ADDENDUM #4 to RFP 20-093

BID NUMBER: 20-093 ISSUE DATE: Monday, November 30, 2020

PROCUREMENT FOR: Design/Build of Roof Repairs at Howard Recreation Center

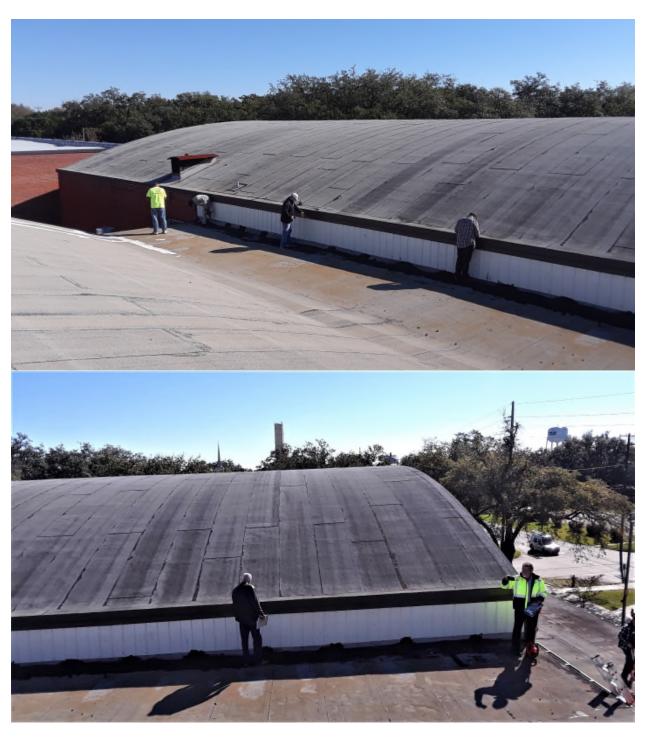
1) With the apparent source of the leaks having been more specifically identified, the Department will reduce the scope of the project to concentrate on the flat center and front corridor roofs, and will NOT include either the arched gymnasium roof, nor the arched auditorium roof. See the REVISED Project Area Below with the highlighted colored area. As discussed in the prebid, the brick wall where the corridor roof joins the Auditorium roof will be treated with a fully adhered membrane as an if it were part of the roof structure. See the attached photos in Exhibit A for illustration of this wall.

- 2) This project will require a Bid Bond be submitted with the submittal, along with a payment and material bond required from the awarded contractor prior to construction.
- 3) The project will remain for treatment with a fully adhered membrane in the newly designated area, including the brick wall where the corridor roof joins the Auditorium roof.

Vertical wall to receive fully adhered membrane treatment.

Vertical wall to receive fully adhered membrane treatment.
